**STAFF REPORT
ITEM NO. A.**

DATE: *November 9, 2015*

ADDRESS: *307 and 315 East Capitol Avenue*

COA REQUEST: *Exterior renovations and signage*

The Paragon Building Existing North Facade 2015

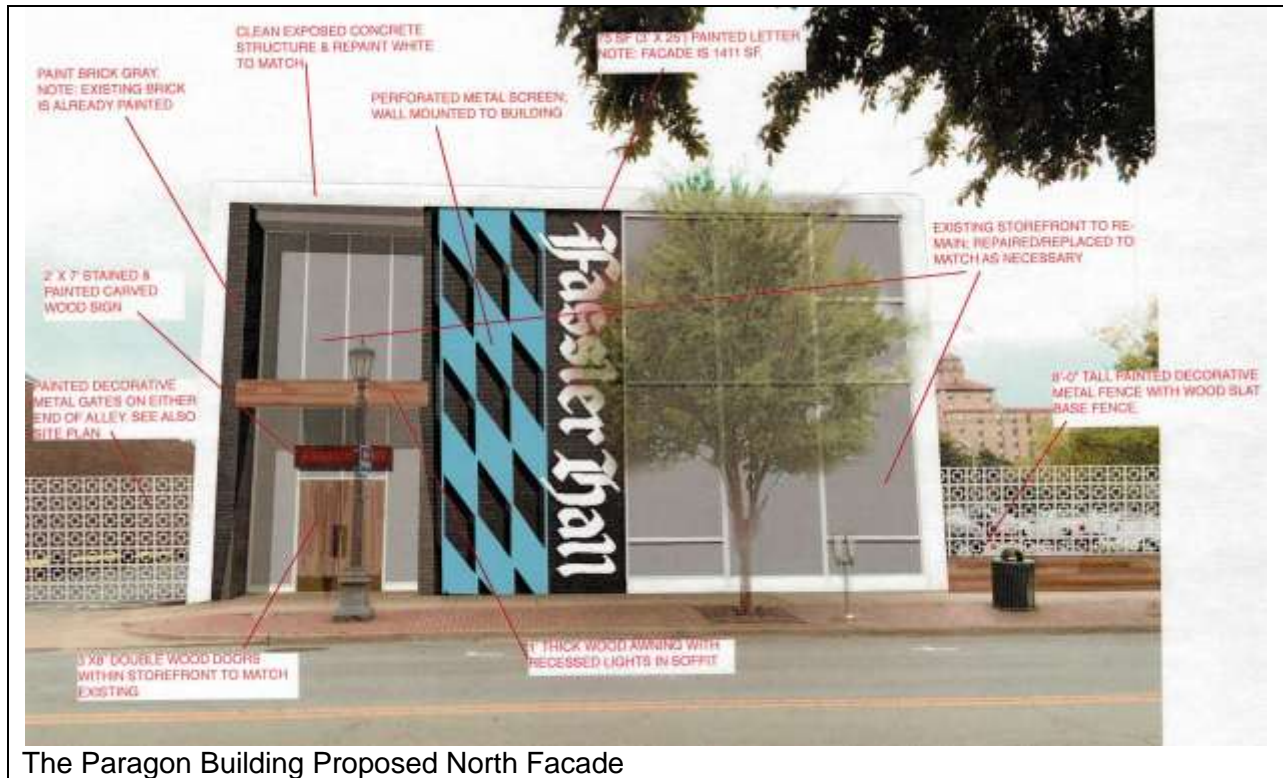
In light of the additional information from AHPP, Staff is concerned on the removing or covering of original architectural details. In this Structural Expressionist building, the three elements are the white structural members, the rectangular masses of brick and the two-story glass storefront windows. AHPP believes that the mortar was dyed and matched to the brick and that this front façade brick has never been painted. Evidence of paint on the mortar joints is not there. The guidelines state on page 49 that unpainted masonry should not be painted.

The sign on the front façade of the building could be installed as metal individual cut letters mounted into the brick as the decorative screen is proposed to be. A different color combination could be used if the red/blue was not found suitable. The sign is quite large and measures differently than labeled. The zoning ordinance states that signs must be less than 10% of the façade. This sign appears to be almost at that maximum.

The sign on the front façade of the building measures almost six feet wide by twenty five feet tall. As proposed, the painted sign would be appropriate if the painting of the brick wall behind was appropriate. However, a metal sign with individual cut letters could be appropriate if they were attached into the mortar and stood away from the brick surface. No mention of lighting of the sign was made in the application.

1. Obtaining building permit for each property.
2. Paragon Building:
 - a. Do not paint brick on front (north) façade,
 - b. Sign on front (north) façade to be individual cut metal letters mounted into the mortar joints.
 - c. Reduce size of sign on front (north) façade by 25%.
 - d. Reduce height of fence to 4' including wood slats.
 - e. Sign on West façade to be reviewed by BOA.
3. American Legion Building
 - a. Reduce height of all fences to 4'.
 - b. Reduce number of signs to two. Remove sign on flagpole and smaller wall mounted sign.

The Paragon Building Existing West Façade 2015

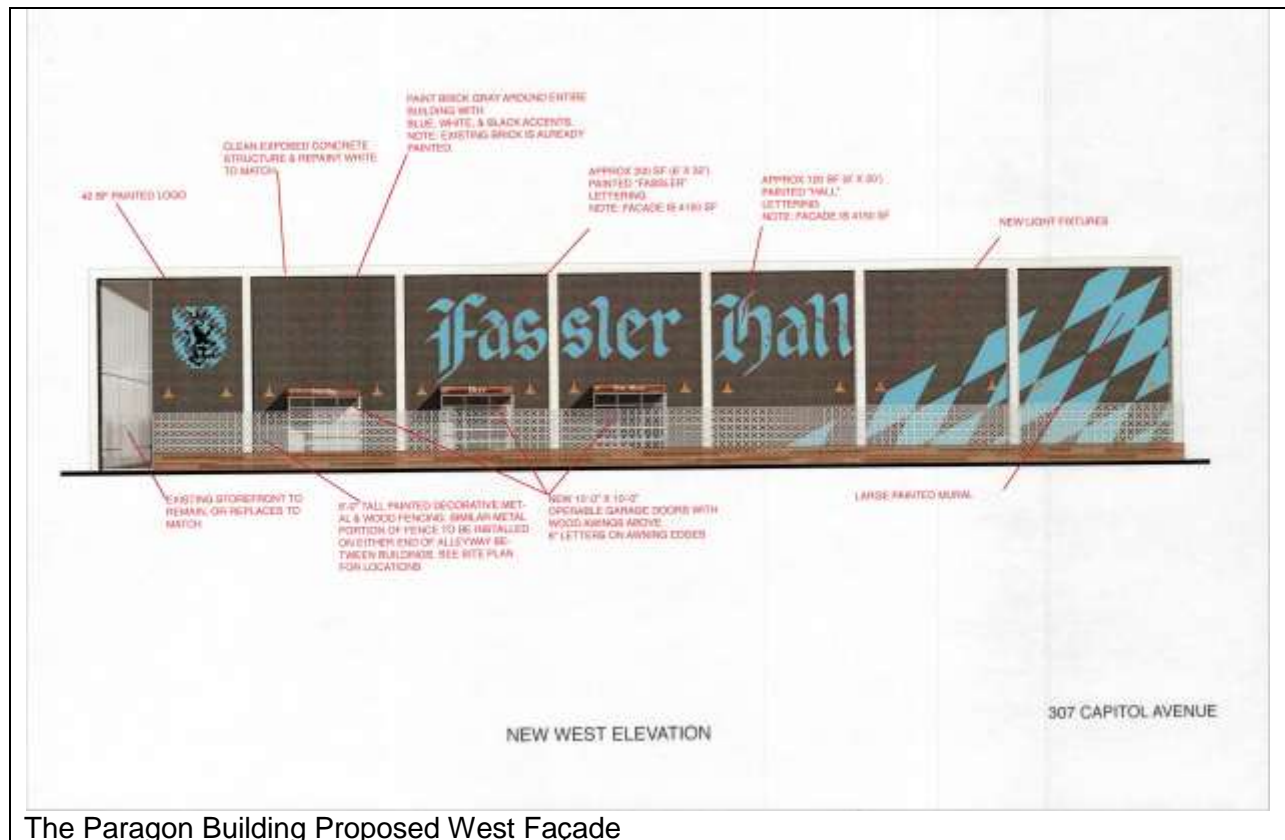
17. A proposed sign of 120 square feet sign (6' x 20') is proposed to be painted on the second floor of the building. (The dimensions of this sign are not correct, the building is approximately 150 feet long, the seven bays are approximately 22 feet long each, therefore the sign is approximately 60 feet long and from 6-13 feet high for an area of 540 feet.)

The sign on the west wall would be appropriate for materials, but may still be oversized at approximately 540 square feet based on the elevation provided. The size noted is incorrect. It will need to be reviewed by the Board of Adjustment since it does not have street frontage. The logo without words on it (diamond shield with griffin) may not be considered a sign. It is 42 square feet. The sign, Fassler Hall, is a sign without street frontage. This sign will require to be reviewed by the Board of Adjustment. Sec. 36-557 (a) All on-premises wall signs must face required street frontage except in complexes where a sign without street frontage would be the only means of identification for a tenant.

The Paragon Building Existing East Façade 2015

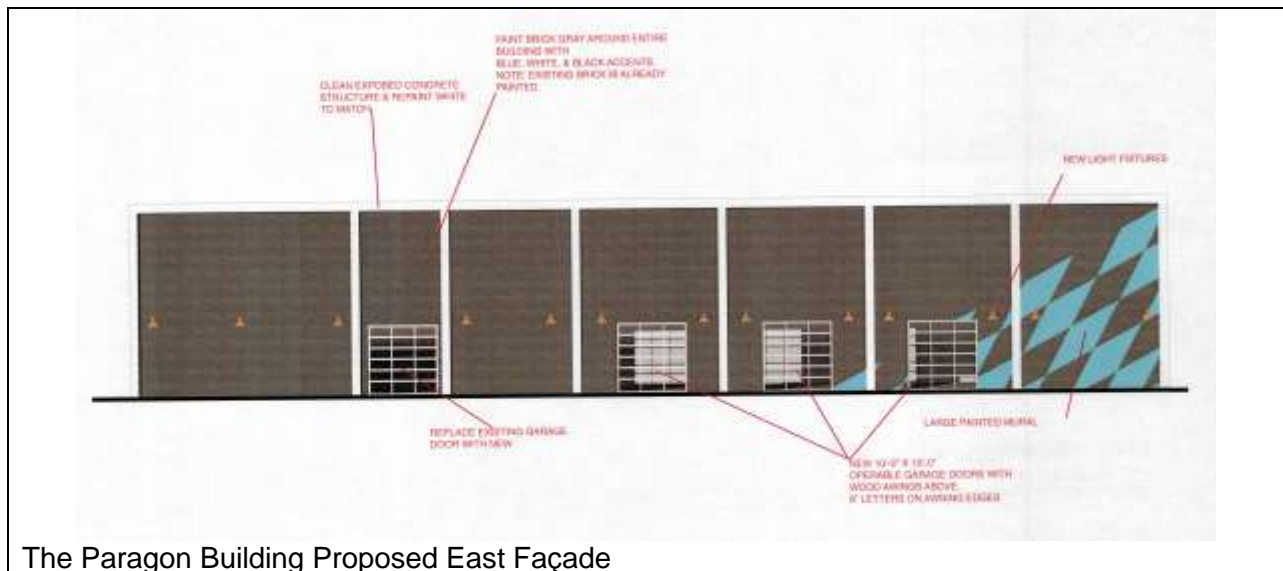
On the east and west façade, it has been painted previously and further painting on these two facades will not diminish the contributing status of the building. Cutting six additional overhead doors into the building may make the building non-contributing in the next survey. Ralph Wilcox, in an email date November 2, 2015, stated "I believe that if the building is renovated and the garage doors are put into the building as proposed, that the project will make the building non-contributing." Mid Century modern buildings are unique to the district.

The American Legion Proposed North Façade

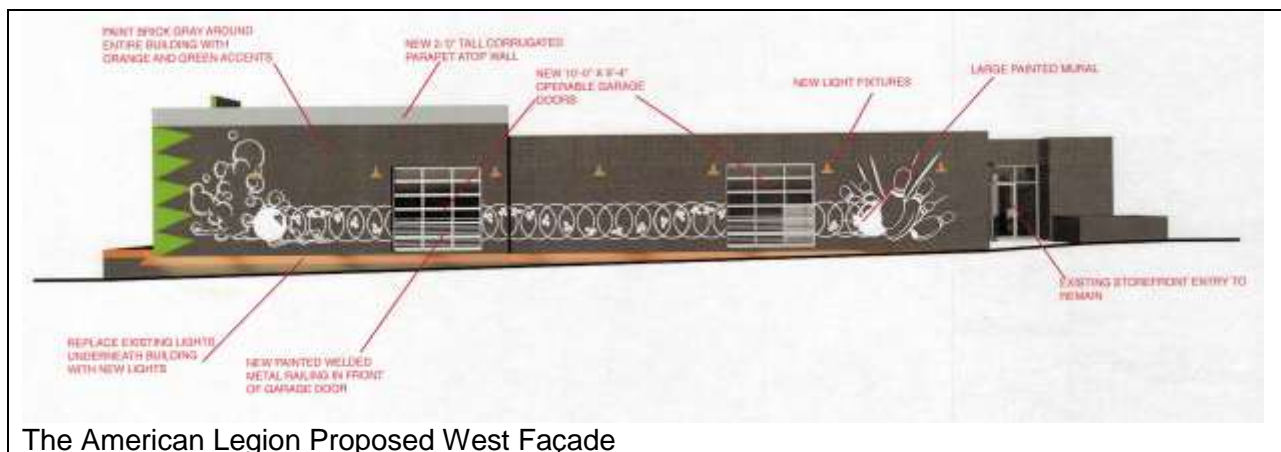
The guidelines state that brick that has not been painted before should not be painted. This brick appears to be able to withstand weather and is not mismatched. When the planter wall is cut and infilled, it may not be possible to reuse the brick or match it with new brick. Later mortar is more difficult to remove from brick in an effort to reuse them. Currently, the proposal is to paint both buildings gray. With the Paragon building front façade recommended to be left unpainted, and it is desired for both buildings to match, then a suggestion would be to paint the Eberts building to match the Paragon Building. Reutilizing the existing brick to fill voids in the planter wall would be the best solution and not requiring the brick to be painted.

The proposal is for four signs on the front of the building. From the left (east side), the first is the 2' tall metal letters mounted to the top of the canopy. This would be about 24 square feet. The second is a wall sign noted to be 3'x7 but scales approximately 16'x5' for 80 square feet. The third, a wall sign with the bowling pin on it, is labeled 8' in diameter for about 70 square feet. The last sign is on the existing flagpole.

This zoning ordinance for this UU zoned land states that freestanding signs (the sign on the flagpole) my not to exceed six feet in height, including pole. This sign is clearly taller than six feet. Staff feels that four signs on this façade is too much signage. Staff believes that the two

signs on opposite ends of the building (the large neon wall sign and the metal sign on top of the canopy) would be sufficient.
